HISTORIC AND DESIGN REVIEW COMMISSION

HDRC CASE NO: 2020-448
ADDRESS: 415 HAYS ST
LEGAL DESCRIPTION: NCB 528 BLK 1 LOT 12
ZONING: IDZ-1, H
CITY COUNCIL DIST.: 2
DISTRICT: Dignowity Hill Historic District
APPLICANT: Juan Fernandez/CVF LLC
OWNER: CVF LLC
TYPE OF WORK: New construction of three, 2-story single family residential structures
APPLICATION RECEIVED: December 18, 2020
60-DAY REVIEW: Not applicable due to City Council Emergency Orders
CASE MANAGER: Edward Hall

The applicant is requesting a Certificate of Appropriateness for approval to construct three, 2-story, single-family residential structures on the vacant lot at 415 Hays, located within the Dignowity Hill Historic District.

Historic and Design Review Commission
Design Review Committee Report

1 SITE PLAN
SCALE: 1/8" = 1'-0"

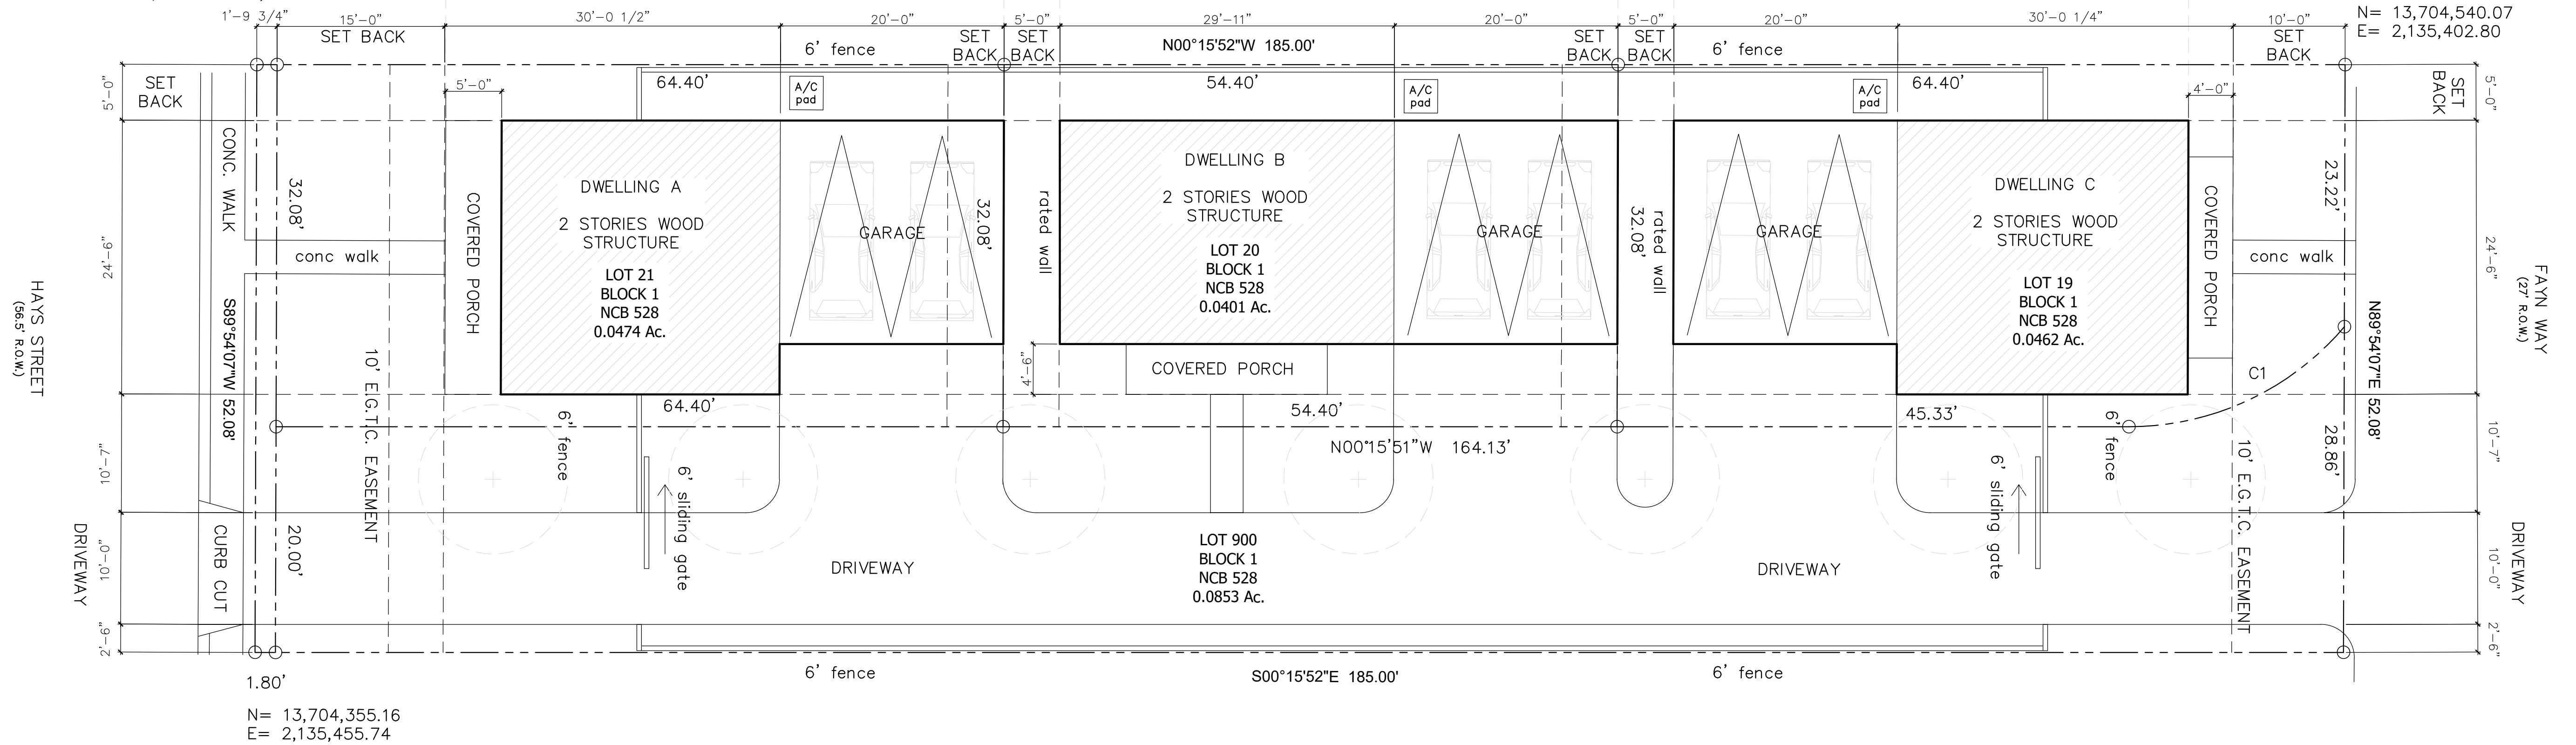
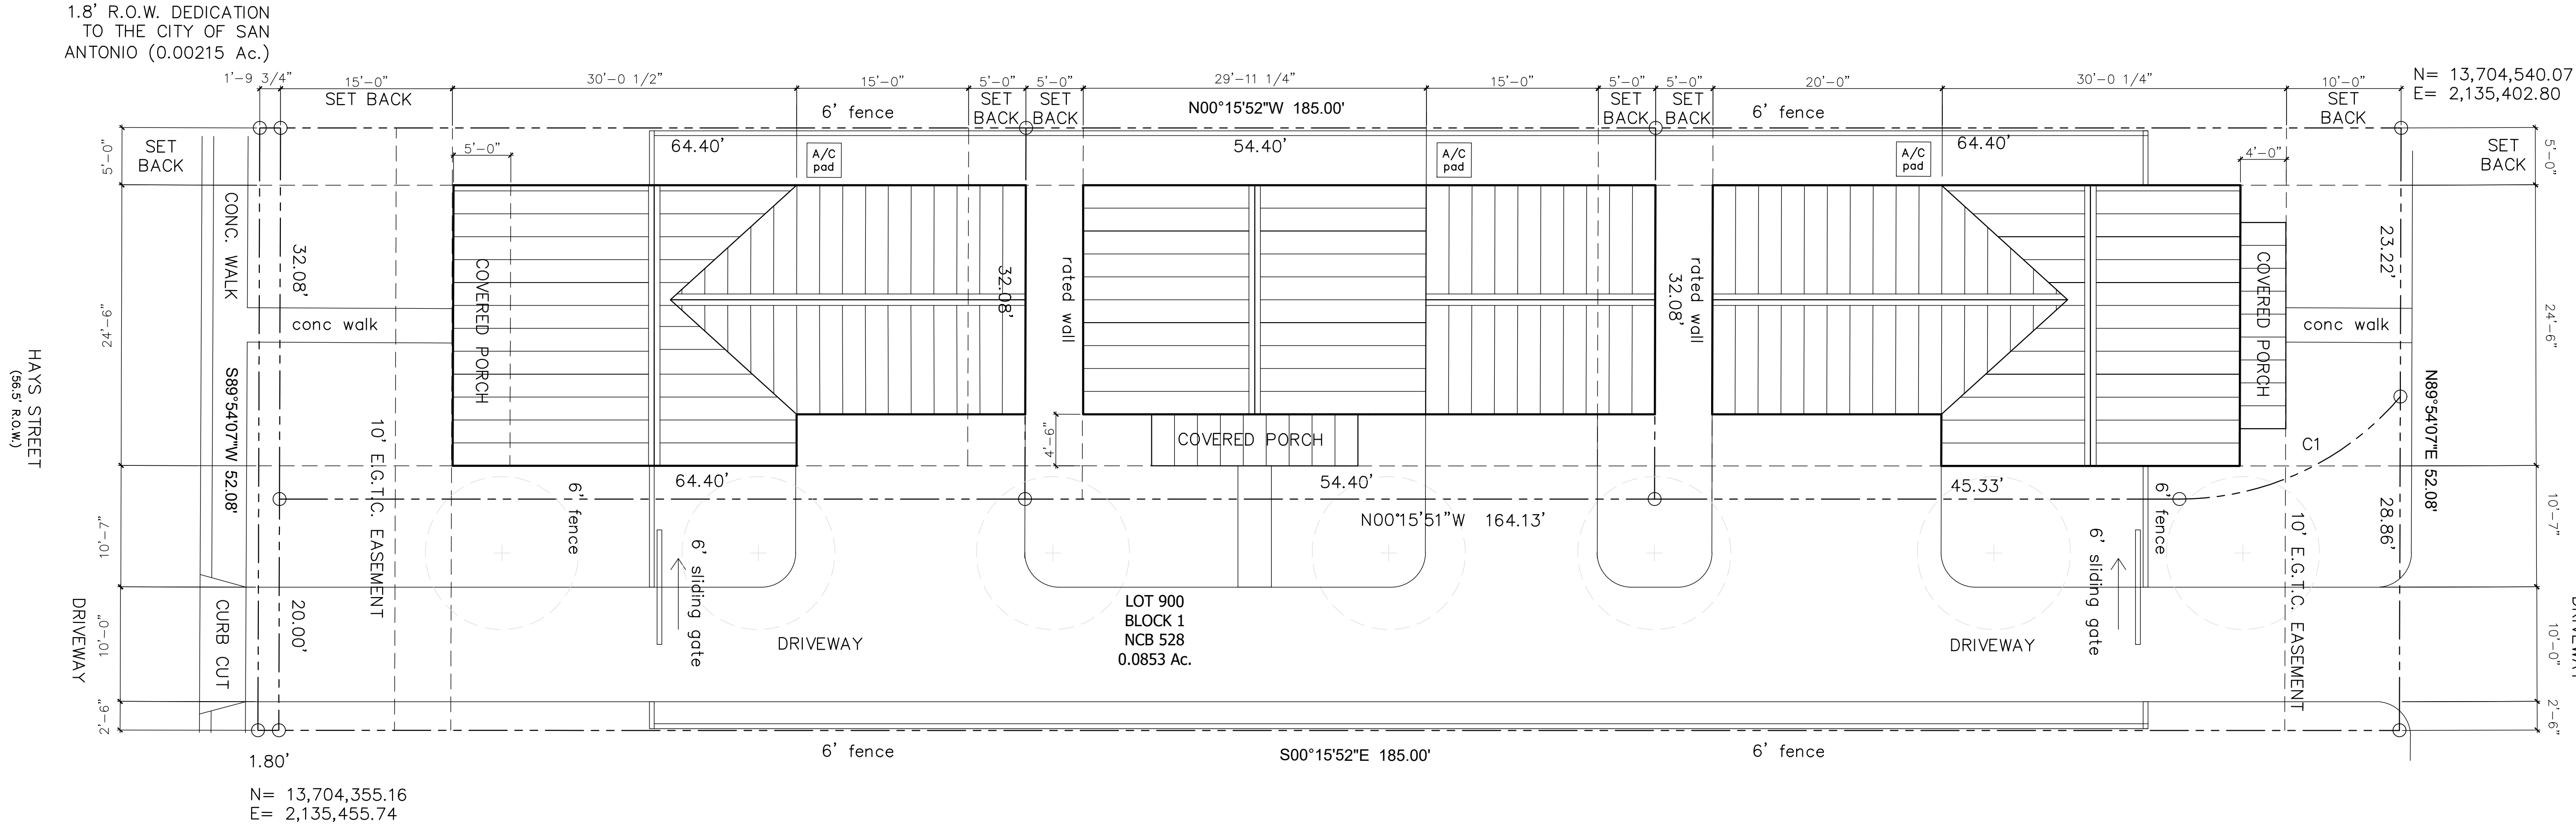
- e. SETBACKS & ORIENTATION (Hays) – According to the Guidelines for New Construction, the front facades of new buildings are to align with front facades of adjacent buildings where a consistent setback has been established along the street frontage. Additionally, the orientation of new construction should be consistent with the historic examples found on the block. The applicant has provided a site plan that notes a front setback (from the sidewalk) of approximately seventeen (17) feet. Additionally, the applicant has provided a site plan with adjacent structures and has noted that the proposed setback on Hays will be greater than the adjacent structure to the east. Generally, staff finds that the most appropriate setback for new construction, particularly new construction featuring two stories, would be on that is greater than both adjacent historic structures.

- f. SETBACKS & ORIENTATION (Fayn Way) – The applicant has noted a setback of approximately fourteen (14) feet from the property line on Fayn Way. Staff finds this proposed setback to be appropriate as there are not primary, historic structures to address Fayn Way that establish a historic setback.

- i. That the proposed new construction feature setbacks that are greater than the setbacks of the historic structures to the east and west of this lot, on Hays Street, as noted in finding e.
